COLLINS RADIO COMPANY

EQUIPMENT SERIES: 32S

BULLETIN NO. 4A

SUBJECT: TO IMPROVE CW OPERATION

Figure 1. Physical Location of Cathode Follower Components Affected By This Modification.

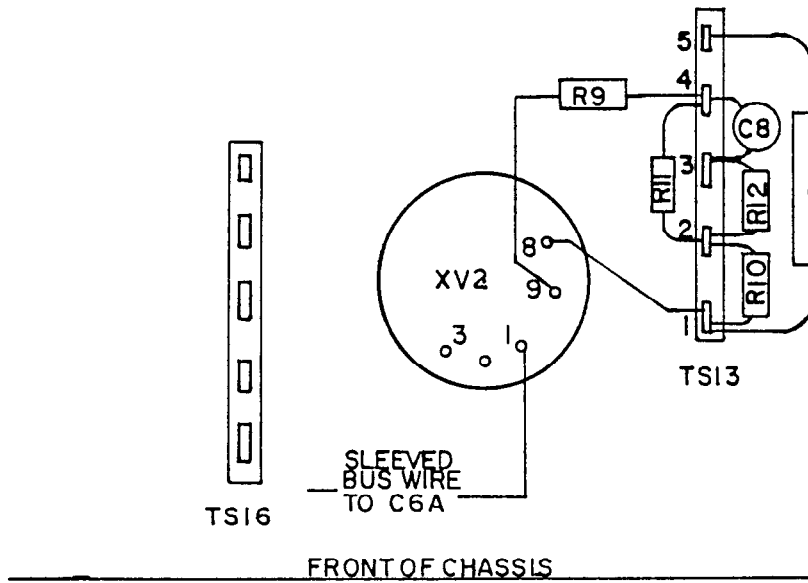
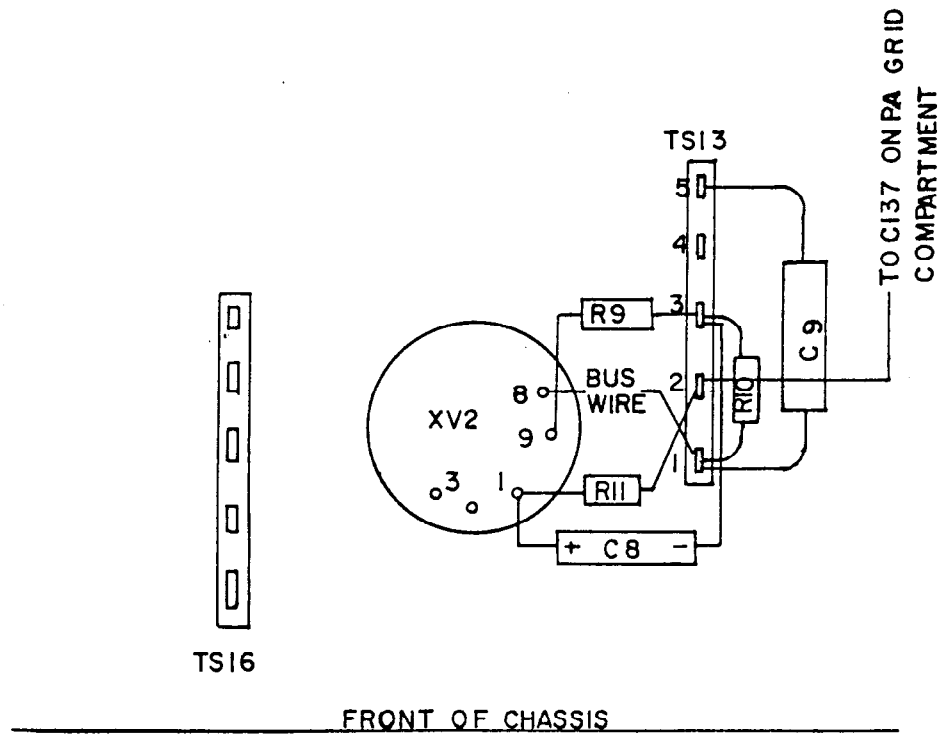
5. Change C115 from a 0.01- to a 0.05-uf capacitor (913-3679-00). This capacitor is located across the KEY jack on back of unit. (CW waveshape characteristics are affected by this capacitor, and the operator may change its value to suit his preference.)
6. Remove 0.01-uf capacitor C8 which is connected between terminals 3 and 4 of TS13.
7. Remove 180K-ohm resistor R11 which is connected between terminals 2 and 4 of TS13.

8. Remove 15K-ohm resistor R12 which is connected between terminals 2 and 3 of TS13.
9. Remove 220-ohm resistor R10 which is connected between terminals 1 and 2 of TS13.

10. Remove wire which is connected from pin 1 of tube V2 to (+) side of 8-uf dual-section fixed electrolytic capacitor C6A. This capacitor is located adjacent to the BFO TEST.

11. Install new 10K-ohm resistor R11 (745-3394-00) from pin 1 of tube V2 to terminal 2 of TS13.
12. Install new 4-uf capacitor C8 (183-1783-00) from pin 1 of tube V2 to terminal 3 of TS13 with plus (+) lead connected to pin 1. It might be advisable to check if any possibility exists in which the (+) lead might short out to another component, if so, sleeve lead with insulation removed from lead of old C8.

13. Connect no. 22 AWG red (439-7068-00) from terminal 2 of TS13 to feed-through capacitor, C137, on PA grid compartment.
14. Install new 1K-ohm resistor R10 (745-1352-00) between terminals 1 and 3 of TS13.

15. Disconnect lead of 220K-ohm resistor R9 which is connected to terminal 4 of terminal strip TS13 and reconnect to terminal 3 of TS13. (The other end of R9 is connected to pin 9 of V2.)

Figure 2. Physical Location of R70 on 32S-1/2 Chassis

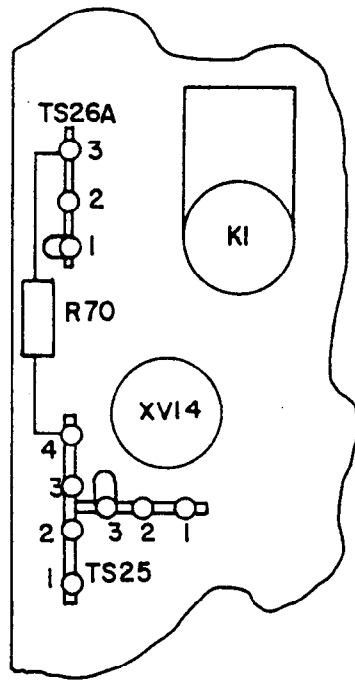
1. Remove Phillips-head screws and four feet from bottom of cabinet.
2. Lift lid and remove the two unpainted Phillips-head screws in the top rim. Slide unit out of cabinet.
3. Turn unit bottom side up with front panel toward operator.
4. Solder a short piece of bus wire across 470K-ohm resistor R70. R70 is located at the left edge of the chassis near relay K1 and soldered between terminal 4 of terminal strip TS25 and terminal 3 of adjacent terminal strip TS26A. (Refer to figure 3.)
